FIELD CHANGE ORDER

Number: 85XBA-R005

Applicability: Retrofit all VAX 85X0s to Revision Level "D1". This FCO incorporated the following ECOs: 851BA-Y-LK004 and 855BA-Y-LK005; New Part Revision "D1".

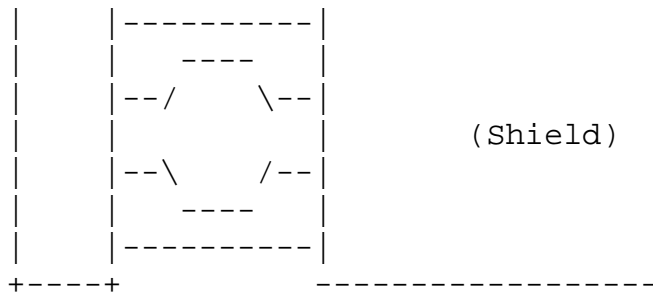
7. Locate Adapter Plate (P/N 74-35168) in EQ Kit. Hold Adapter Plate with studs facing you and large hole on end on your right. This will be the mounting orientation.

8. Mount Adapter Plate over holes for AFS-1 and TS-3 using two flat head screws.

9. Mount AFS-1 to Adapter Plate, using Hex Nut provided, in the location formally occupied by TS-3. Mount TS-3 in the location formally occupied by AFS-1.
